### AMENDMENT TO THE DRAWINGS

U.S. Appln. No. &lt;10/664,294&gt;

**GP-501429**  
Legal Serv. GM Corp., Detroit, MI  
**REPLACEMENT SHEET** *ANNOTATED*  
**7/8**

**FIG 9**

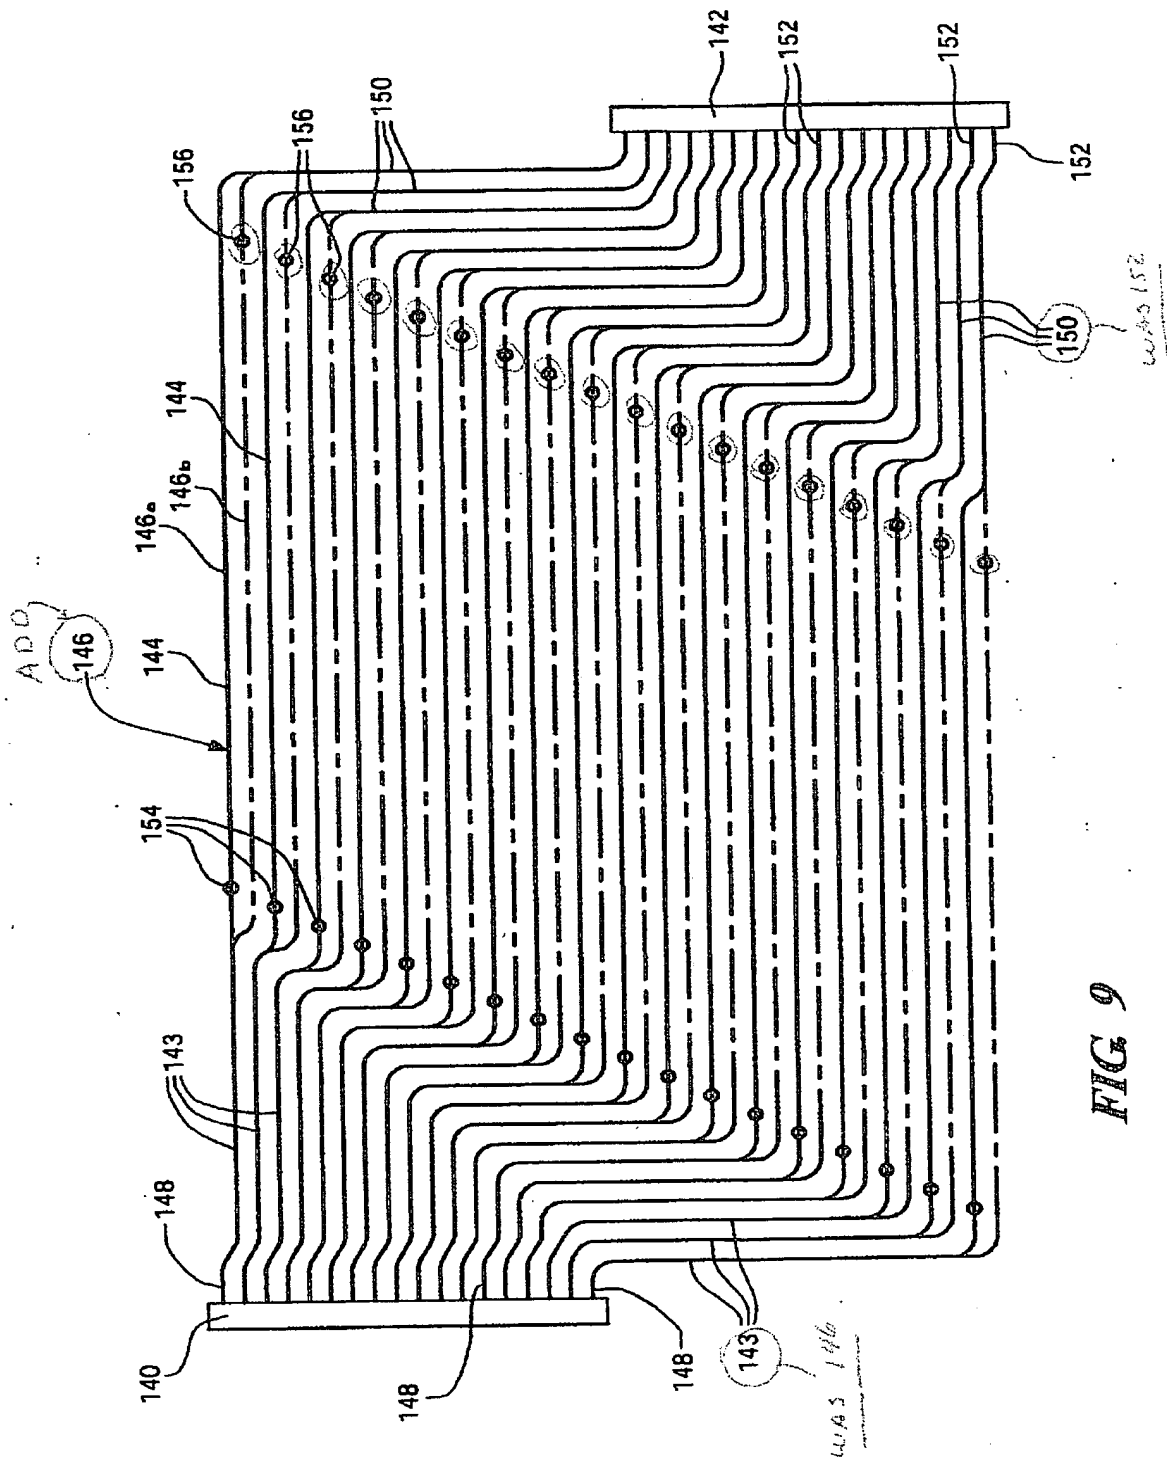
The attached Replacement Sheet of drawings includes changes to Fig. 9 wherein:  
(1) old number 146 has been changed to 143; (2) new number 146 has been added to designate the medial legs of the flow-channels, (3) old number 152 that designated the exit legs has been changed to 150, and (4) flow-restrictors 156 are relocated from flow-channels 146a to flow-channels 146b. An annotated copy of the drawing, showing the changes in red, is also attached.
